**PD Transient Sections 33.3.8.5, 33.3.8.6 (TDL 2.0 #50, 51) Rev 01**

Ken Bennett – Sifos Technologies, Inc., Yair Darshan – Microsemi.

The following content shows the proposed changes for Comment #34.  
(TDL Draft 2.0 Comments 50, 51 will be “OBE” by these changes.)

**Figure 33–36—Type 1, Type 2, and single-signature PD static operating mask**

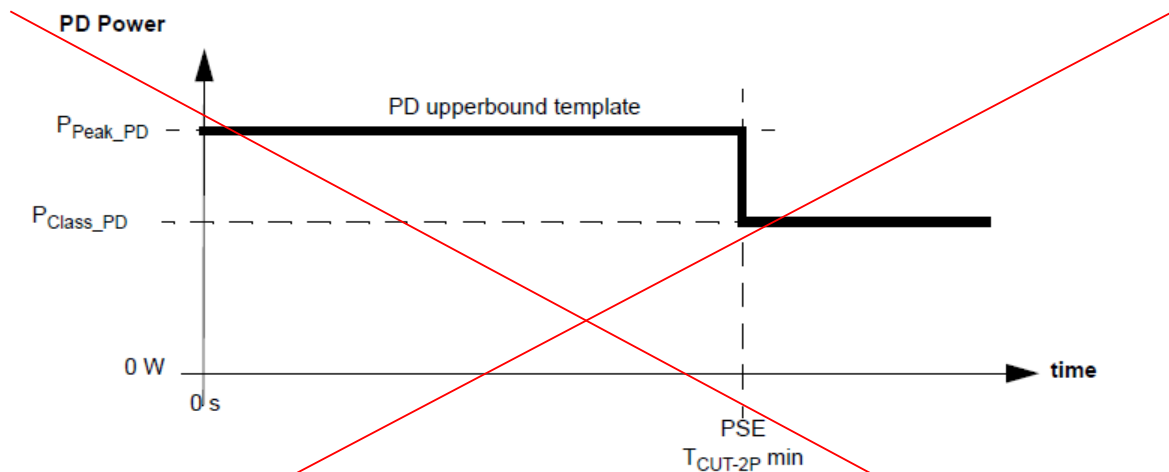
~~Under normal operating conditions when there are no transients applied at the PD PI, single-signature PDs, with the exception of those described in 33.3.8.2.1 and 33.3.8.4.1, shall operate below the PD upperbound template defined in Figure 33–36.~~

~~NOTE—PDs are required to meet Equation (33–2) which results in a slightly lower power and current than results from Figure 33–36, Figure 33–37, Figure 33–38, Equation (33–28), Equation (33–29) and Equation (33–31).~~

~~The PD upperbound template in Figure 33–36,  $P_{SSUT}$ , is described by Equation (33–29):~~

~~where  $t$  is the duration in seconds that the PD sinks  $I_{Port}$ .  $P_{Peak\_PD}$  is the maximum peak operating power, as defined in Table 33–31.  $P_{Class\_PD}$  is the maximum power, as defined in Table 33–27.  $T_{CUT-2P \text{ min}}$  is  $T_{CUT-2P \text{ min}}$ , as defined in Table 33–19.~~

**Figure 33-37—Dual-signature PD static operating mask**

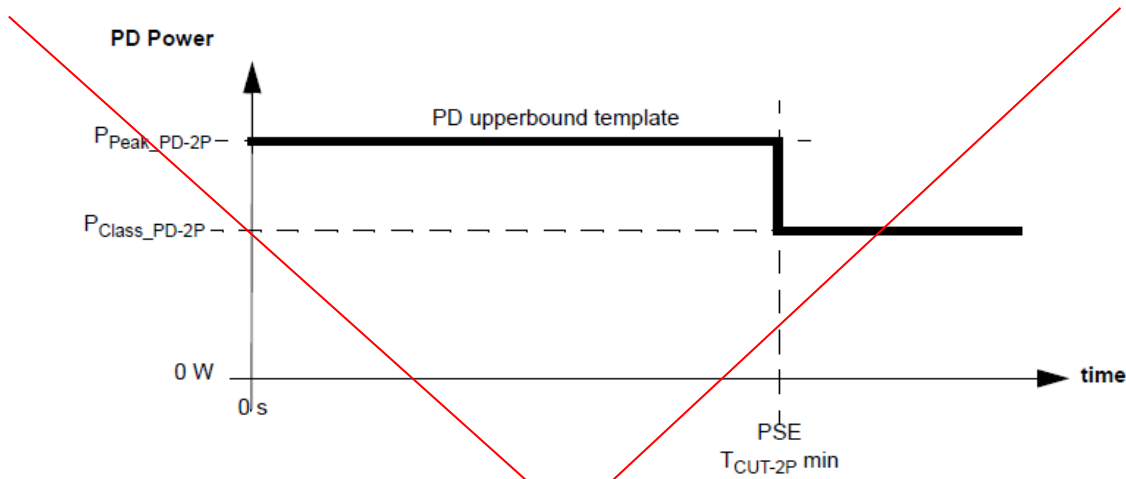
1 ~~Dual-signature PDs shall operate below the PD upperbound template defined in Figure 33-37.~~

**Figure 33-38—Class 6 and Class 8 PDs described in 33.3.8.2.1 and 33.3.8.4.1**

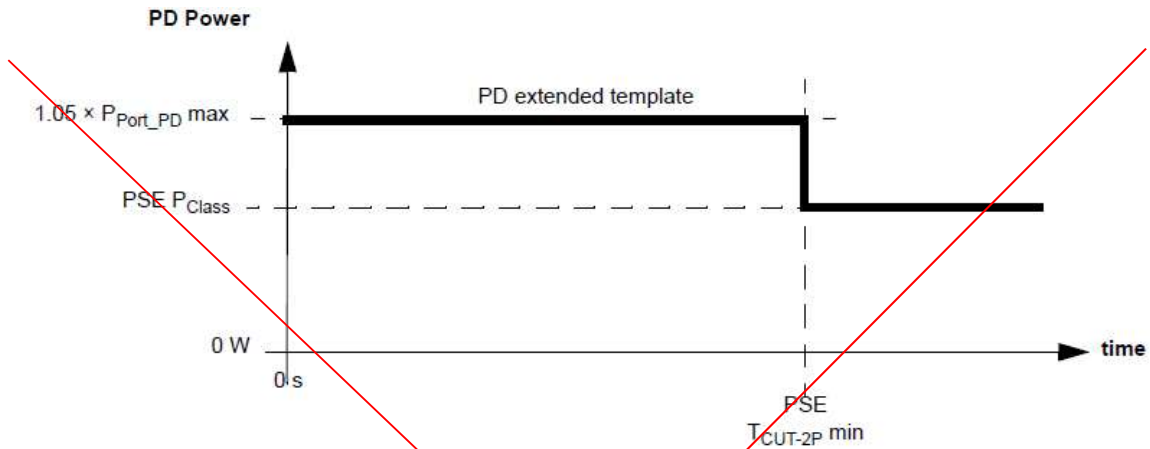
3 ~~PDs described in 33.3.8.2.1 and 33.3.8.4.1 shall operate below the PD extended template defined in Figure 33-38.~~

**Fig. 33-36—Transient Test Conditions Operating Bounds**

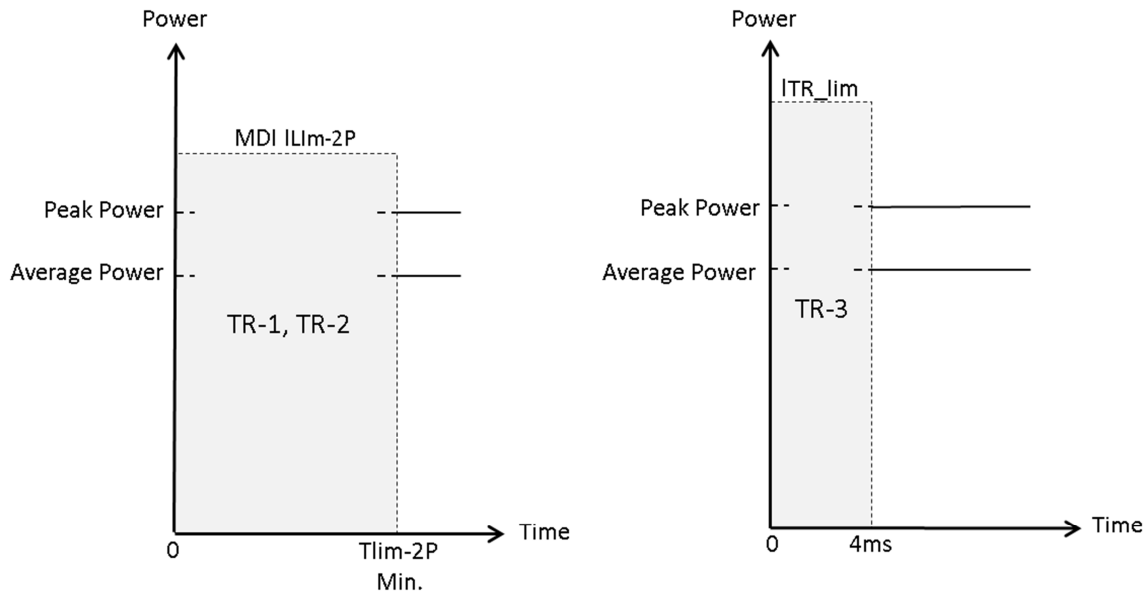
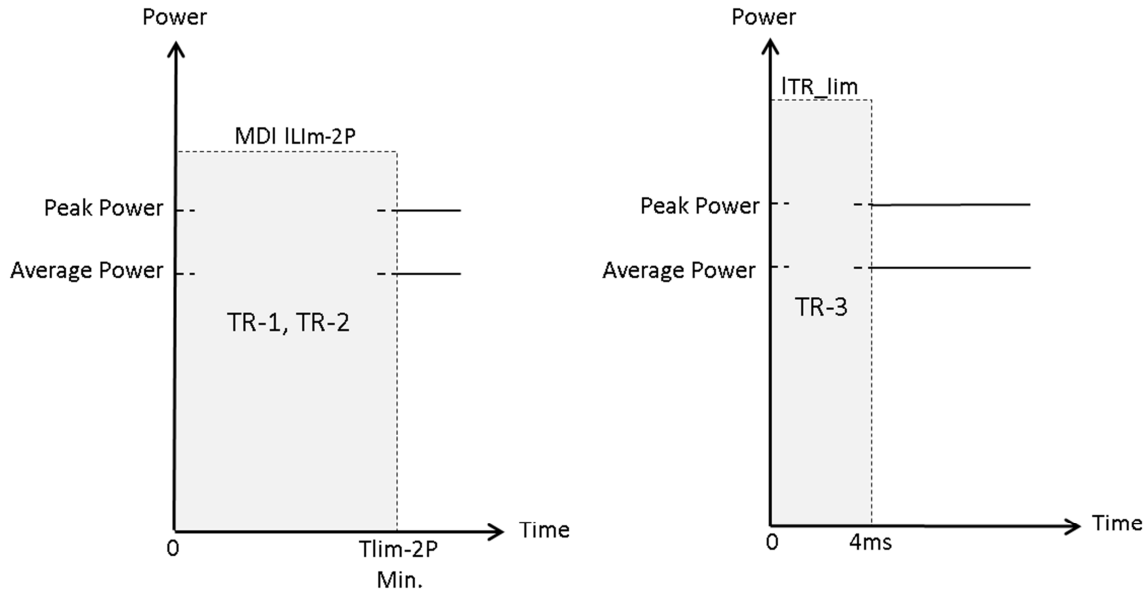
Fig. 33-36 shows operating bounds for the transients in table 33-32. The shaded regions begin with the application of the transient test and end at the times indicated in the figure. These shaded regions can exceed normal operating limits and are not included in the average and peak operating power requirements set forth in table 33-31.

Fig. 33-36 shows transient test condition operating bounds, where:

Average Power is PClass\_PD or PClass\_PD-2P as specified in Table 33-31 and section 33.3.8.2, or the average power limit specified in 33.3.8.2.1, if the applicable conditions for that section are met.

Peak Power is Ppeak\_PD or Ppeak\_PD-2P, as specified in Table 33-31 and section 33.3.8.4, or the peak power limit specified in 33.3.4.1 if the conditions for that section are met.

TR-n shows the operating bounds of the transient test condition, where n is the number of the test condition. These are not subject to the normal average and peak power limits.

Fig. 33-36 shows operating bounds for the transients in table 33-32. The shaded regions begin with the application of the transient test and end at the times indicated in the figure. These shaded regions can exceed normal operating limits and are not included in the average and peak operating power requirements set forth in table 33-31.

Fig. 33-36 shows transient test condition operating bounds, where:

- Average Power is PClass\_PD or PClass\_PD-2P as specified in Table 33-31 and section 33.3.8.2, or the average power limit specified in 33.3.8.2.1, if the applicable conditions for that section are met.
- Peak Power is Ppeak\_PD or Ppeak\_PD-2P, as specified in Table 33-31 and section 33.3.8.4, or the peak power limit specified in 33.3.4.1 if the conditions for that section are met.
- TR-n shows the operating bounds of the transient test condition, where n is the number of the test condition. These are not subject to the normal average and peak power limits.
- Tlim-2P min. is the minimum Tlim-2P value for the PD class, defined in table 33-19.
- MDI Ilim-2P is the limited source current defined in Eq. 33-29.
- ITR\_lim is the maximum allowed PD current defined in table 33-33.
